ANA Garrison at Kunduz Does Not Meet All Quality and Oversight Requirements; Serious Soil Issues Need to Be Addressed

April 30, 2010

SIGAR Audit-10-09

Figure 2: Master Plan of Kunduz ANA Garrison, Phase I

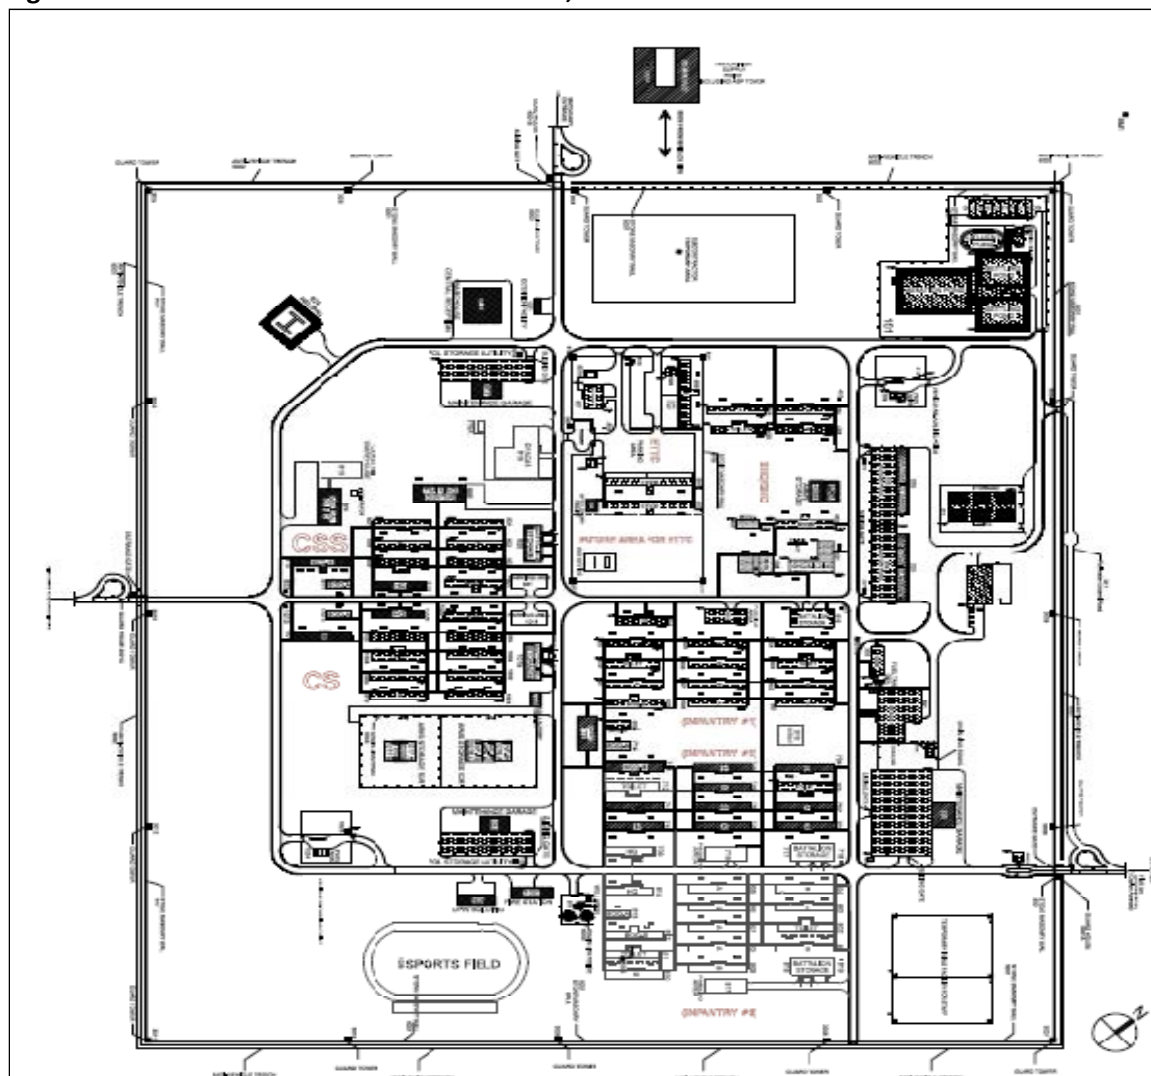
"As shown in figure 2, the master plan details two phases"

The diagram does not show Phase I and Phase I. Recommend replacing Figure 2 with the diagram that depicts all phases.

5. We modified the report to indicate that the diagram shown in figure 2 does not show Phase II of the Kunduz ANA garrison.
6. We modified the report to indicate that current plans call for housing German soldiers at the embedded training team compound.
